#### **DEPARTMENT OF TRANSPORTATION**

#### **National Highway Traffic Safety Administration**

#### **Federal Motor Vehicle Safety Standards; Seat Belt Assemblies**

**ACTION:** Final rule.

Figure 8: Acceleration Corridors

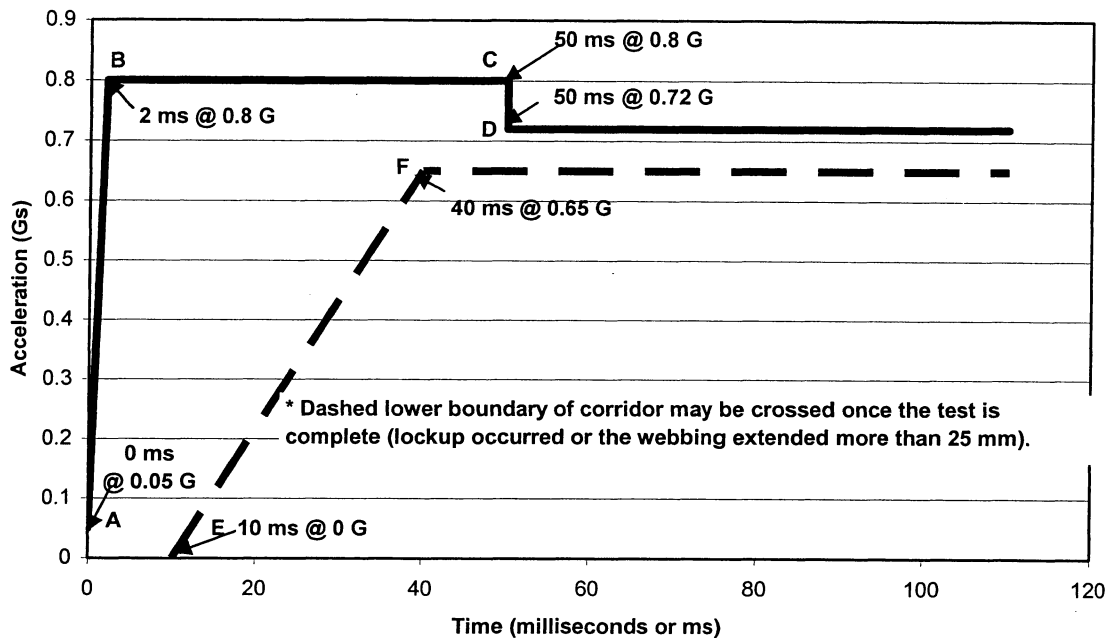
- The final rule modifies that portion of FMVSS No. 209's test procedures relevant to ELRs by adopting a new Figure 8 which provides a specified acceleration-time corridor for test pulses. The A–T corridor includes an upper boundary onset rate of 375 g/sec and permits acceleration to peak at up to 0.8 g. The lower boundary of the A–T corridor allows for a minimum onset rate of 21.67 g/sec. The steady-state tolerance range is from 0.65 g to 0.72 g.

In response to these comments, the agency has decided to modify the lower boundary of the A-T corridor in the manner suggested by the AORC in its latest submission. NHTSA's intention in proposing the lower boundary in the NPRM was to ensure that it encompassed current test pulses, particularly those with slower onset rates. Although the AORC did not provide any data to demonstrate the nature and extent of this "nuisance locking" problem, we believe that the AORC's proposed new lower boundary would address the concern of potential "nuisance locking," while maintaining inclusion of all current test pulses. In addition, we believe that the new lower A-T corridor should minimize the variation in onset rates, while maintaining the repeatability and reproducibility of the test procedures.

The agency notes that in this final rule, we have modified the lower boundary of the A-T corridor such that the initial peak must be obtained within 40 ms. However, we do not believe that this modification will impact any existing compliant ELR because agency data show that current acceleration pulses reach 0.7 g well before 40 ms.

- 2. Section 571.209 is amended by:
  - a. Revising S4.1(a) and (b), S4.3(j), and S5.2(j);
  - b. Adding S5.4; and
  - c. Adding Figure 8 after Figure 7 of § 571.209.

of  $\pm 10$  g and processed according to the practices set forth in SAE Recommended Practice J211-1 rev. December 2003, "Instrumentation for Impact Test—Part 1—Electronic Instrumentation," Channel Frequency Class 60. The webbing shall be positioned at 75 percent extension, and the displacement shall be measured using a displacement transducer. For tests specified in S5.2(j)(2)(iii)(A) and (B), the 0.7 g acceleration pulse shall be within the acceleration-time corridor shown in Figure 8 of this standard.
